For: OPTICAL DETECTOR DEVICE FOR A METER

PETITION TO REVIVE UNAVOIDABLY ABANDONED APPLICATION
UNDER 37 CFR 1.137(B)

AMENDMENT

AN IMPROVED OPTICAL FLOW METER

FIG_5

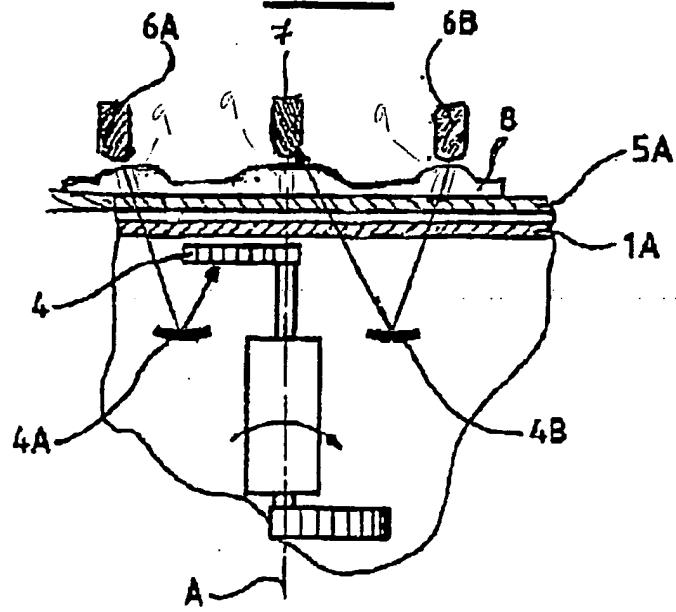
The attached sheet of drawings includes changes to Figure 5. This sheet 3/5, which includes Figure 4 and 5, replaces the original sheet 3/5 which includes figures 4 and 5. In Figure 5, the previously omitted item 9 has been added.

In paragraph 1 of the Office Action, the Examiner has objected to the Figures and claim 9, because the optical collimator device having slits is not shown in the drawings. Applicants have amended Figure 5 and corresponding paragraph [0053] of the specification to show slits 9 in the collimator device. Such amendments to the specification and Figure 5 do not constitute new matter because the slits 9 in collimator device 8 were adequately described in the application as filed in both originally filed claim 9, and paragraph [0018] (beginning on line 21 of page 3) of the specification. In view of these amendments, Applicants request that these objections be withdrawn.

[0053] As can be seen in figure 5, optical beam collimation devices 8, of lens type, may be inserted between the transparent wall 5A of module 5 and the optical elements 6A, 6B, 7, or they may be formed directly by the transparent wall 5A of module 5 configured as a collimation device. This collimator device 8 may comprise slits 9 to limit stray interference between light beams.
